**Eugene School District 4J
ROOSEVELT MIDDLE SCHOOL**
680 East 24th Avenue
Eugene, OR 97405
CIP No. 410.566.001

ADDENDUM NO. 6

This Addendum forms a part of the Contract Documents and modifies the original Bidding Documents dated February 18, 2015 and subsequent addenda as noted below. Acknowledge receipt of this Addendum in the space provided on the Bid Form. Failure to do so may subject the Bidder to disqualification.

HIGH ROOF PLAN - ZONE B

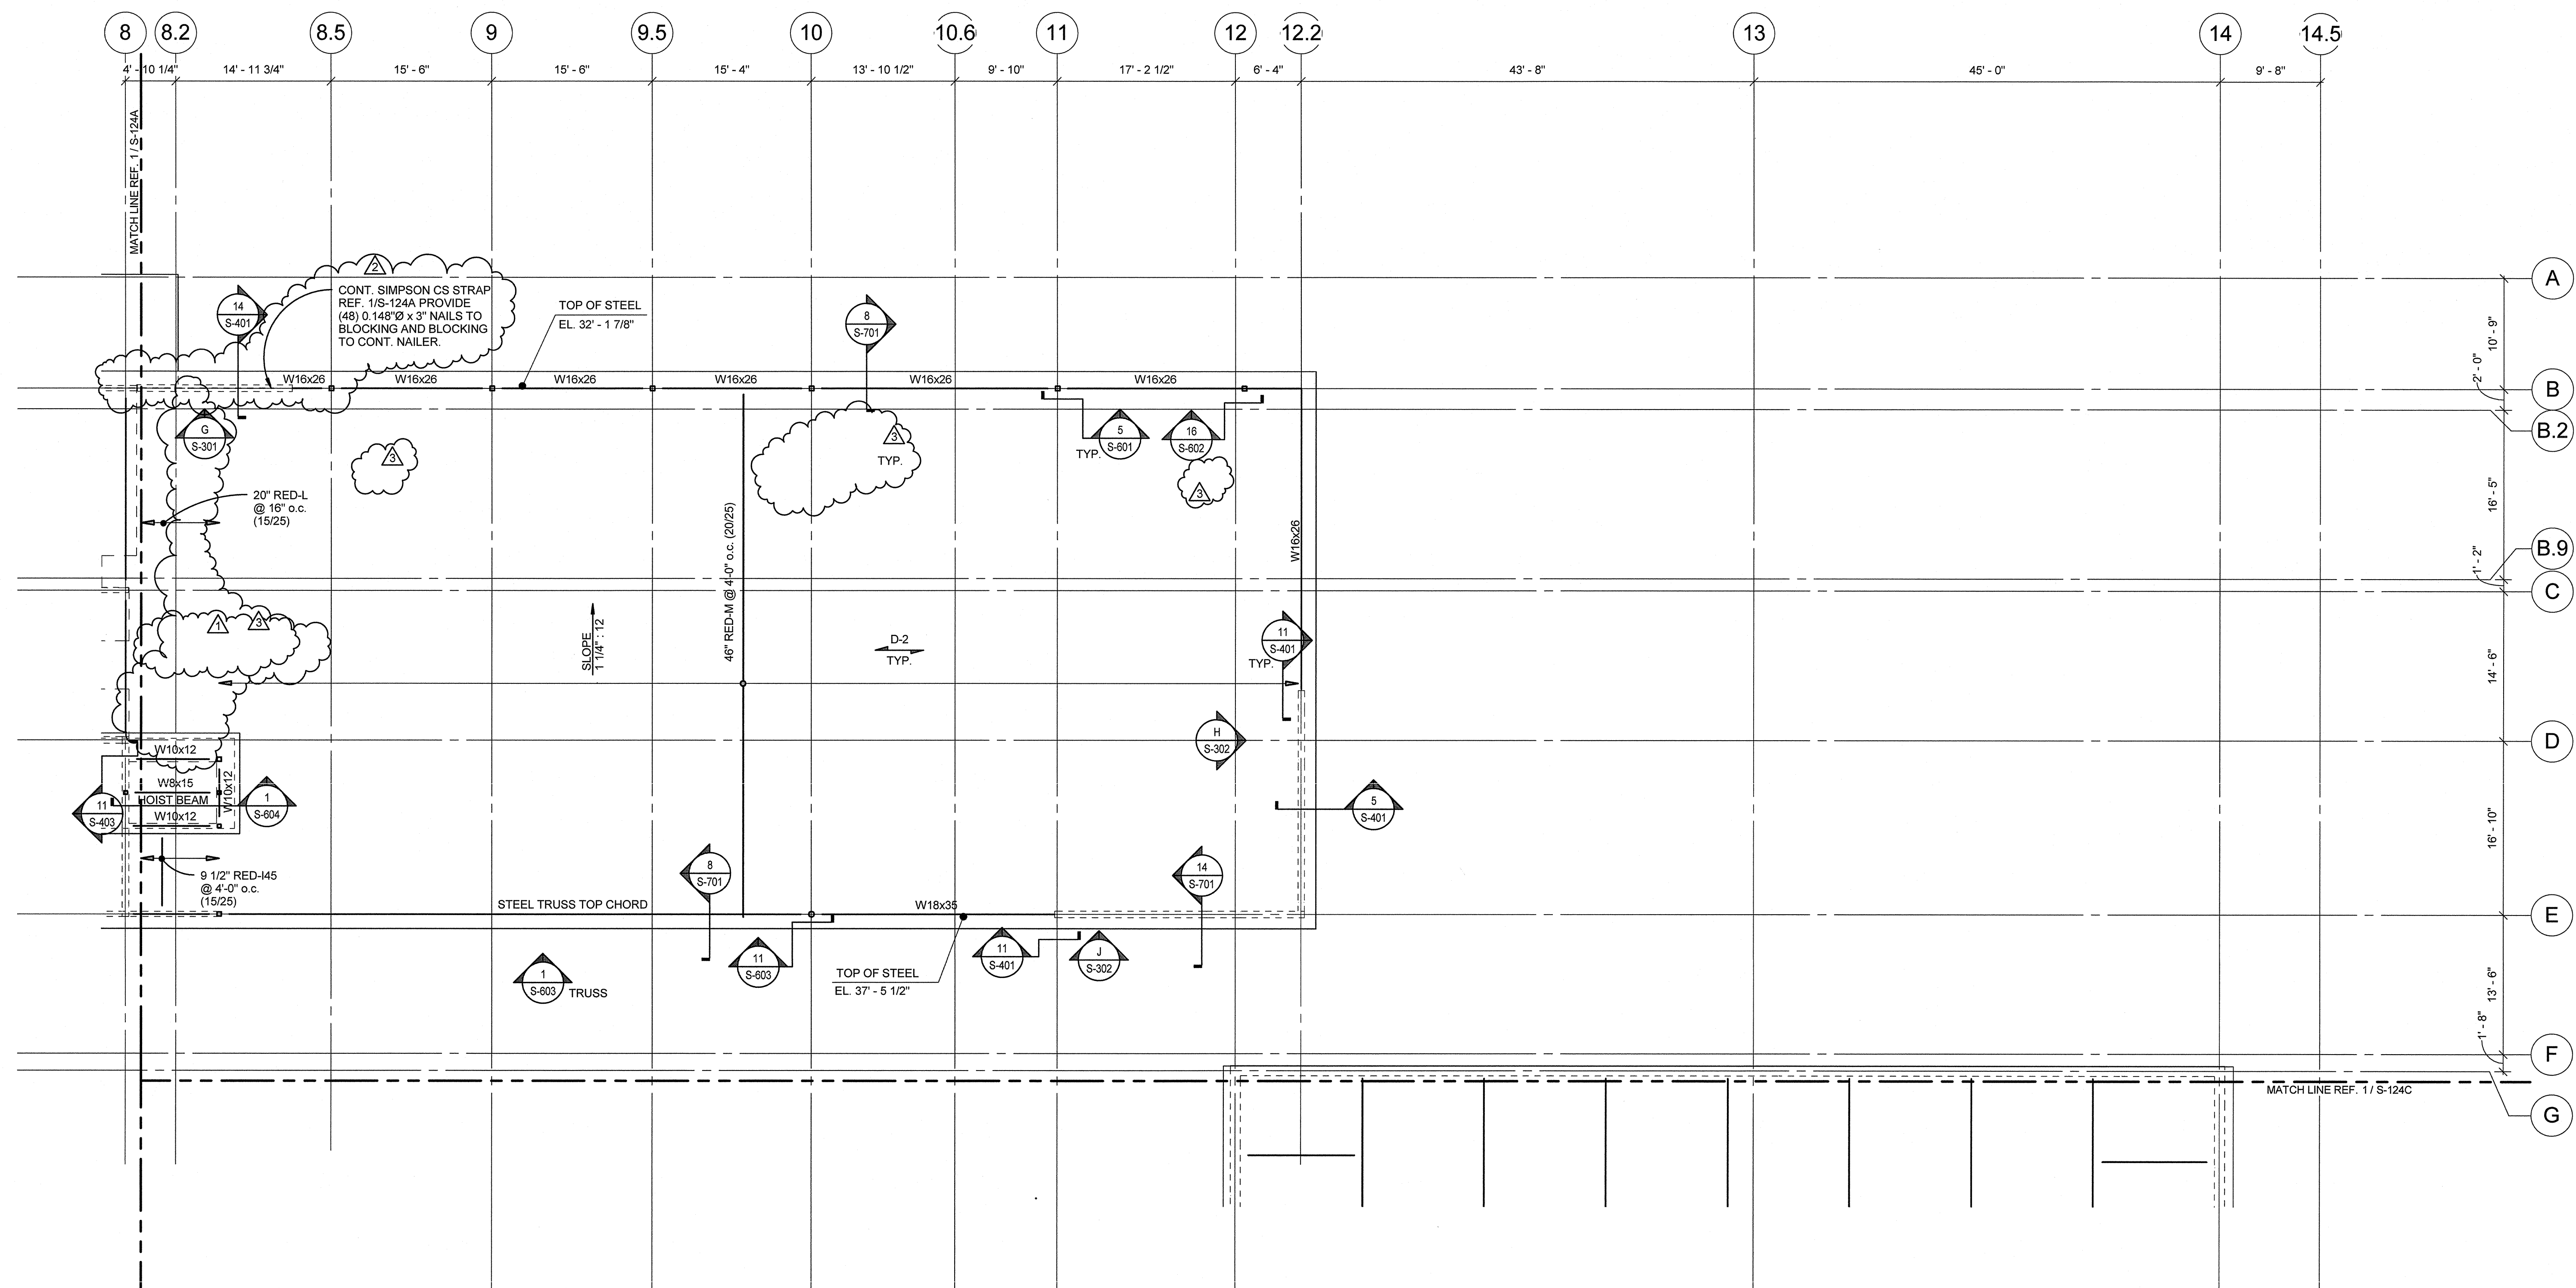
- A. Replace Sheet with revised Sheet S-124B: Delete the roof tie offs. Delete roof access hatch associated framing.

1 HIGH ROOF PLAN - ZONE C
1/8" = 1'-0"

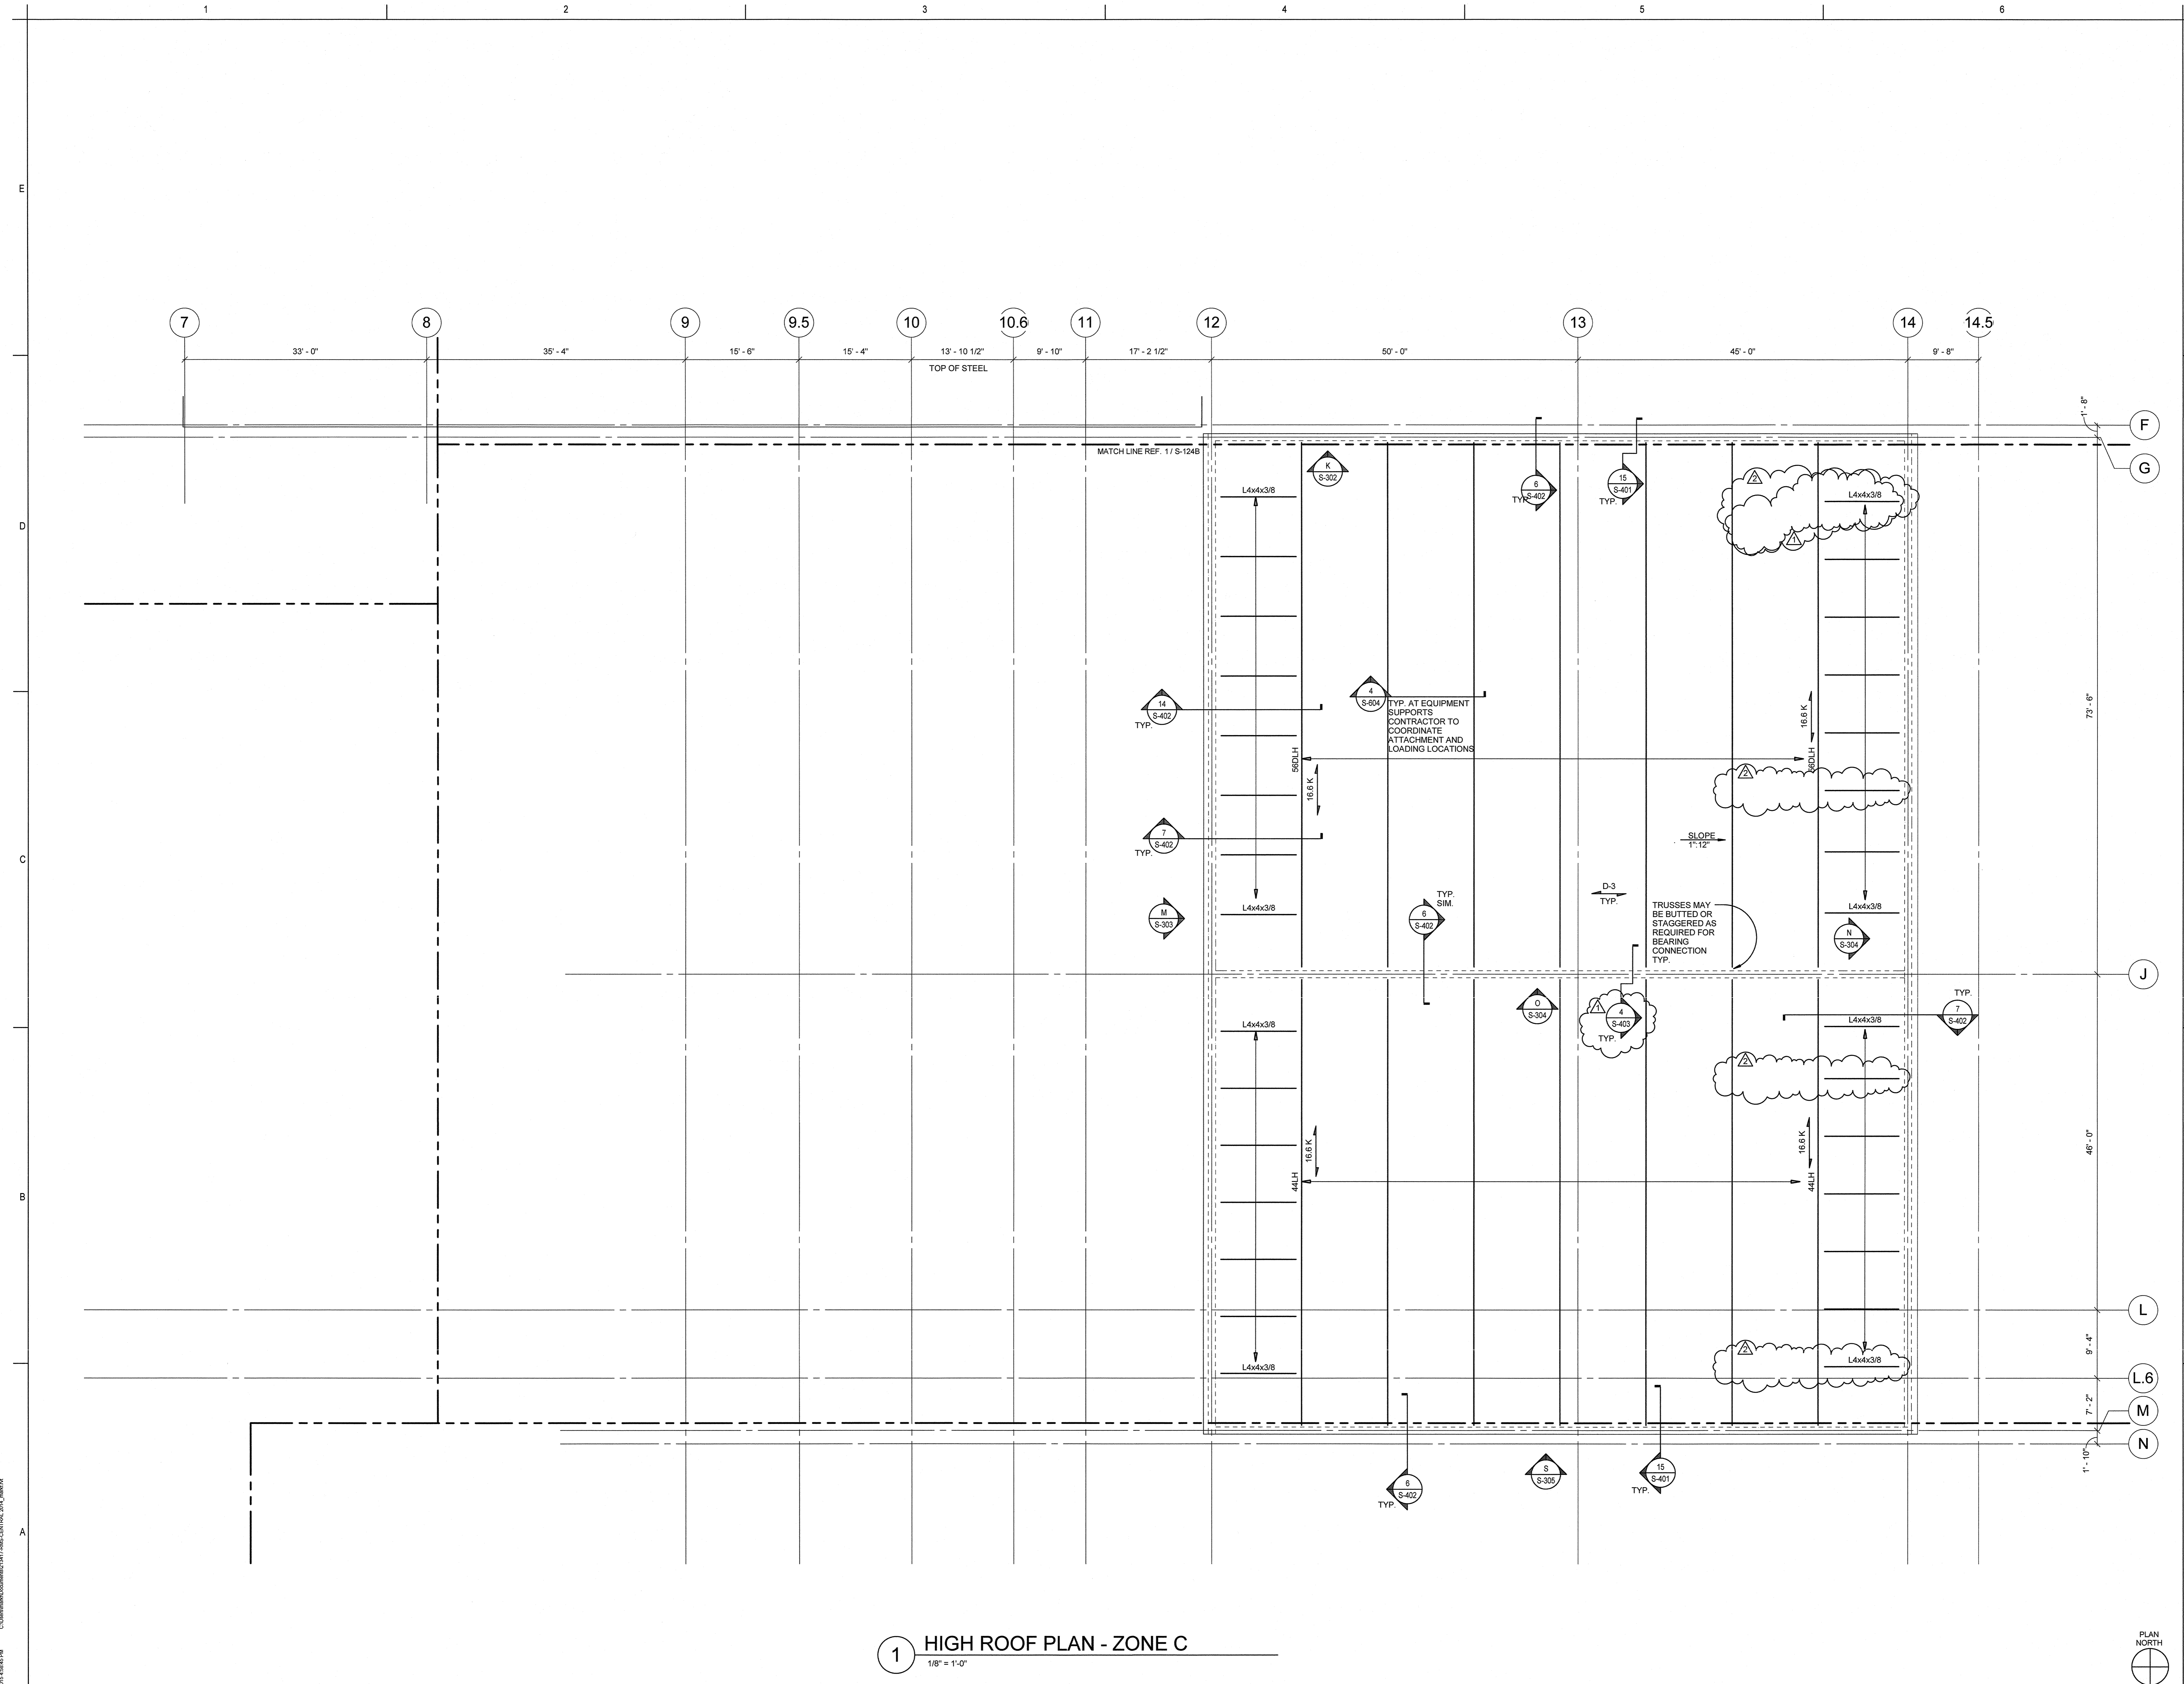
- A. Replace Sheet with revised Sheet S-124C: Delete the roof tie offs.

1 STEEL TRUSS ELEVATION - GRID E
1/4" = 1'-0"

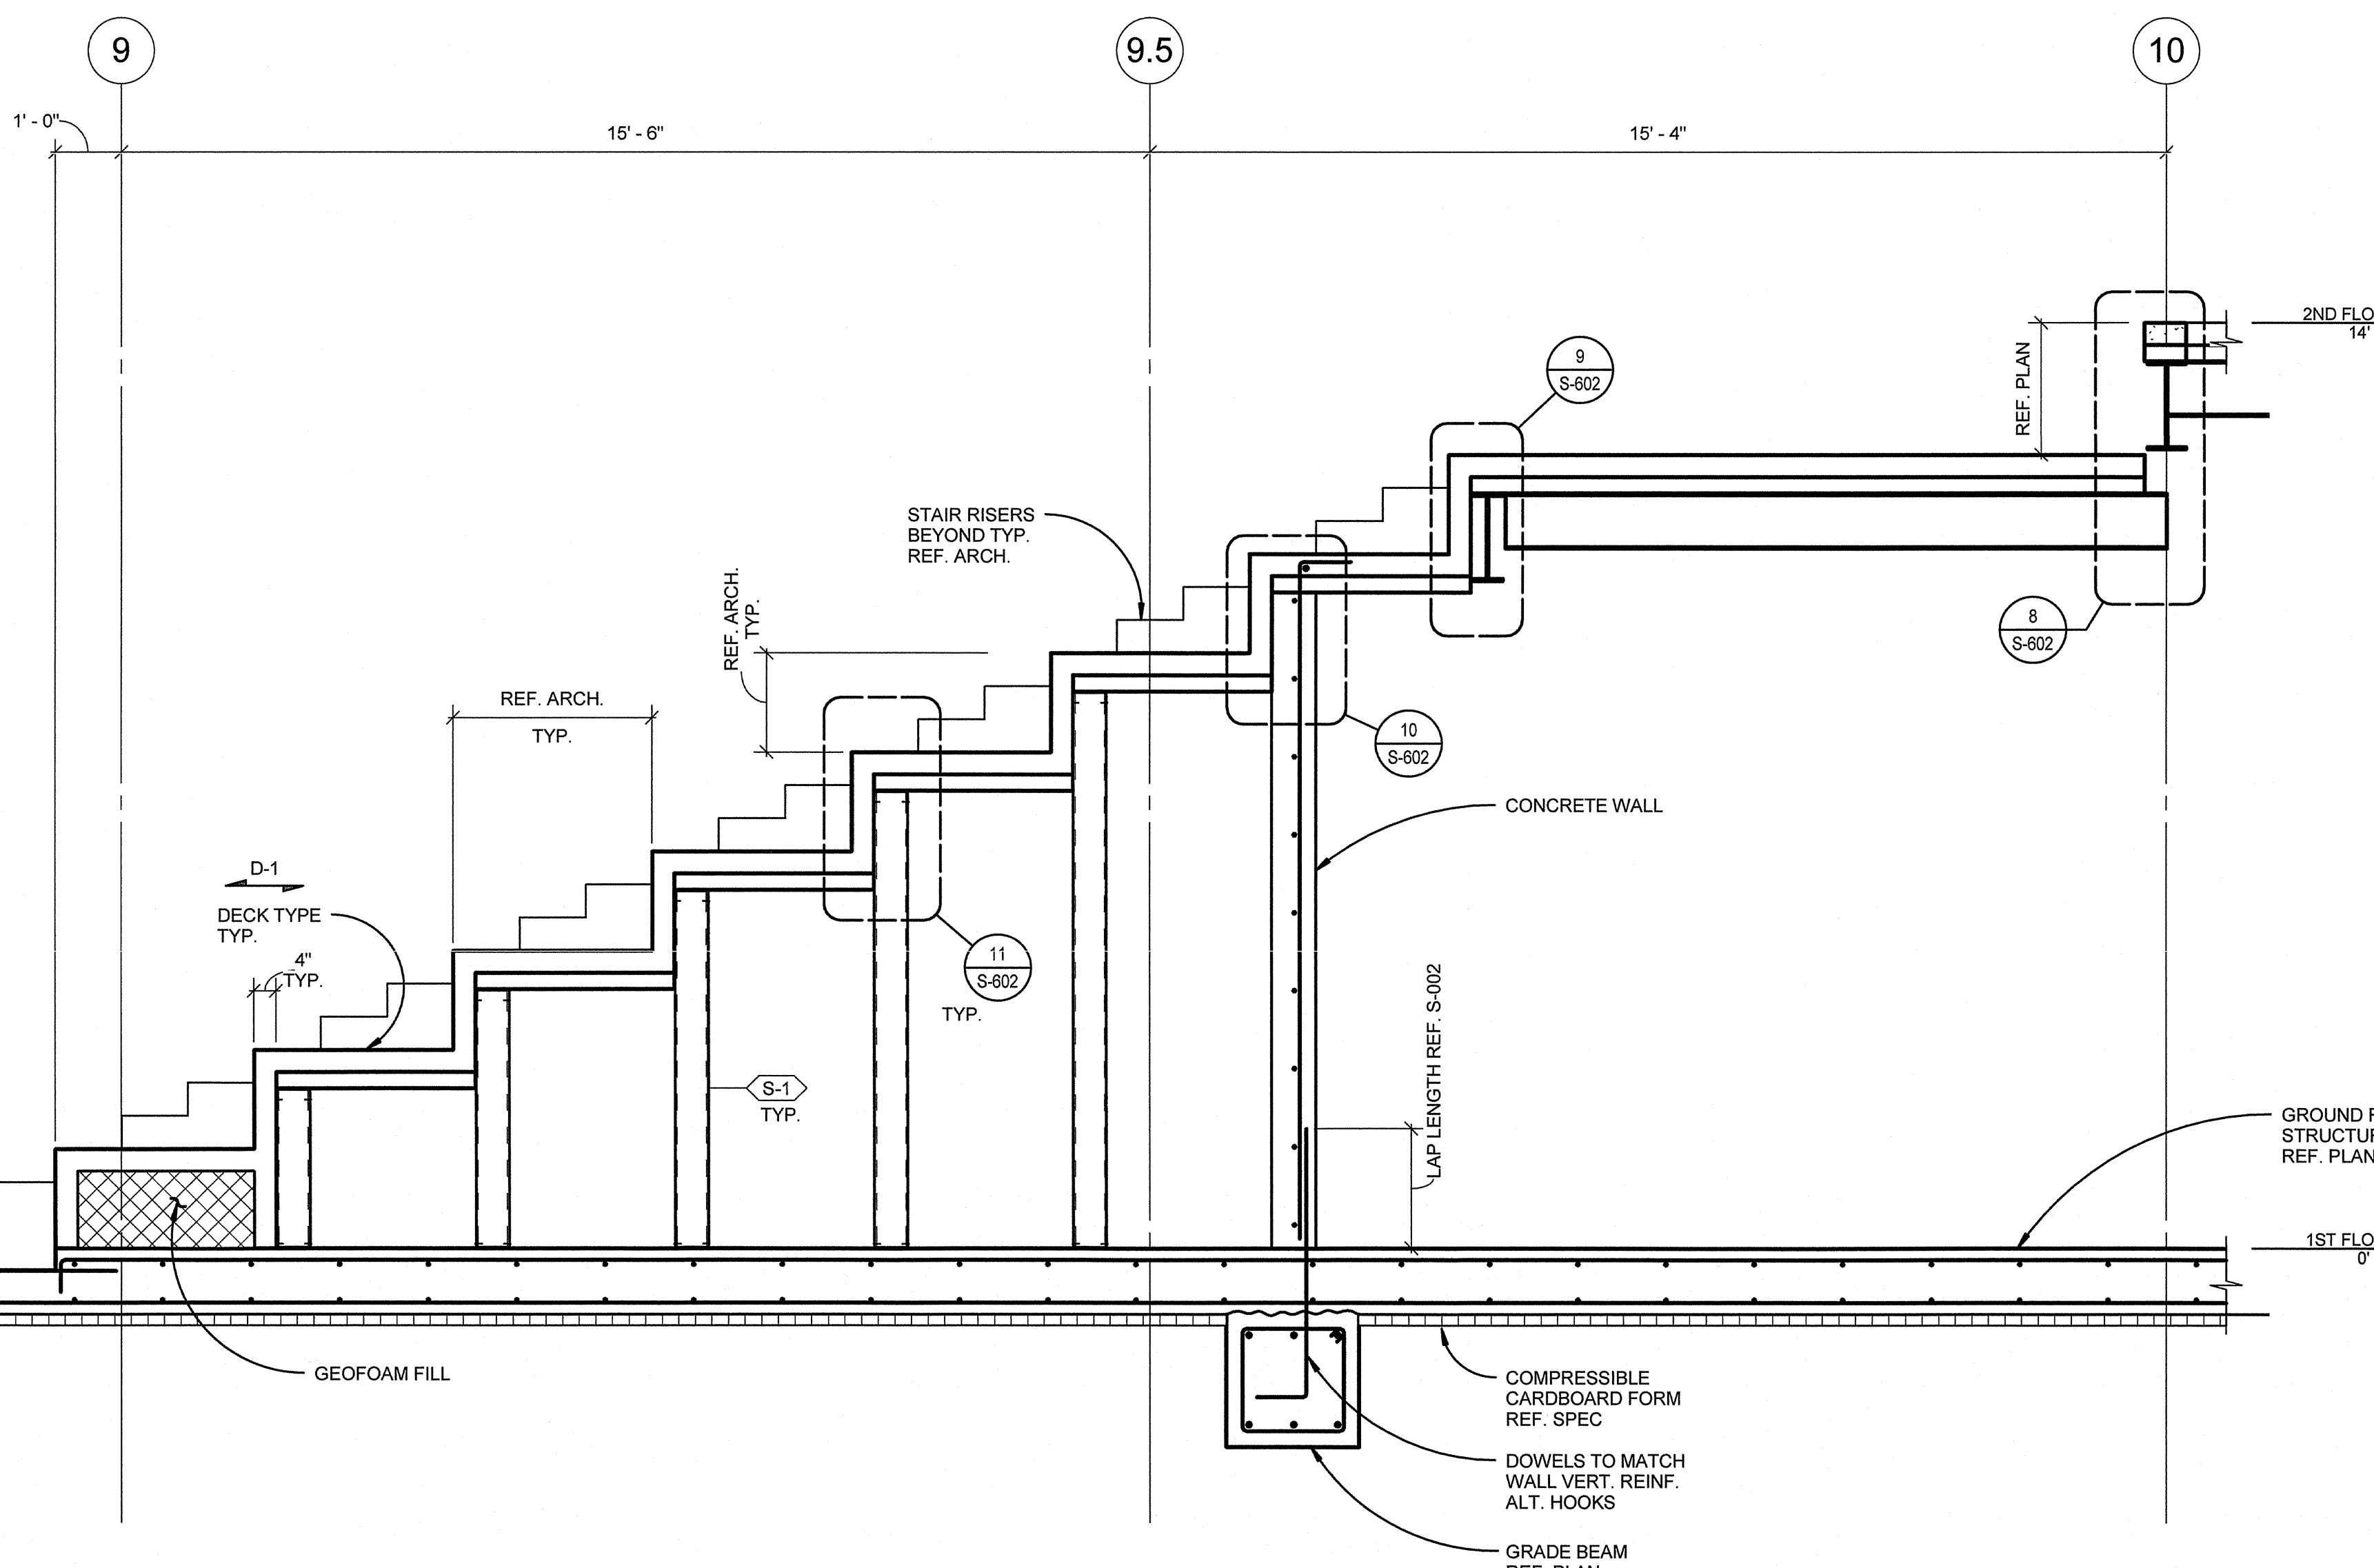
- A. Replace Sheet with revised Sheet S-603: Add vertical truss members in Elevation 1. Add thru-bolts at truss bottom chord in Elevation 1. Revise truss diagonal member sizes in Elevation 2.
